JSP-0767-91 December 23, 1991 10CFR50.12 10CFR50.90

Subject: Application for Exemption from 10CFR50

Appendix J and Amendment of Facility Operating License No. NPF-62 for Clinton Power Station

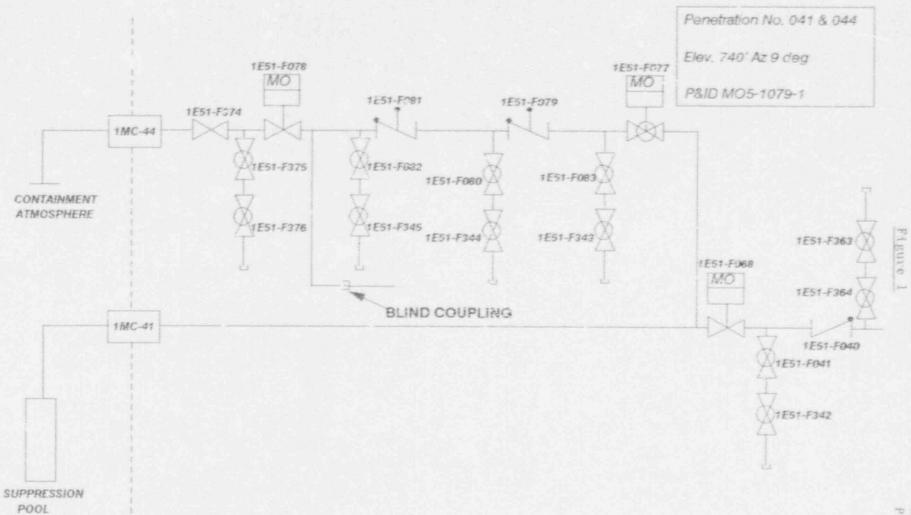
The isolation provisions for the RCIC vacuum breaker line con linment cenetration (1MC-44) and the RCIC turbine exhaust line containment penetration (1MC-41) are depicted on Figure 1 (page 7 of this attachment). Isolation of these penetrations is provided by motor operated valves 1E51-F077, 1E51-F078, and 1E51-F068; test connection/vent/drain valves 1E51-F375, 1E51-F375, 1E51-F082, 1E51-F080, 1E51-F083, and 1E51-F041; check valve 1E51-F040; and a welded blind coupling (which was installed during the second refueling outage in response to the testing deficiencies identified in LLR 90-018). Containment isolation valve 1E51-F078 is tested in the forward direction using valve 1E51-F374 as a test boundary valve. Valve 1E51-F374 is normally open and is closed only to facilitate the performance of LLRTs. As a result, valve 1E51-F374 does not provide a containment isolation function. However, its integrity is required in order to maintain the leak tightness integrity of the containment penetration.
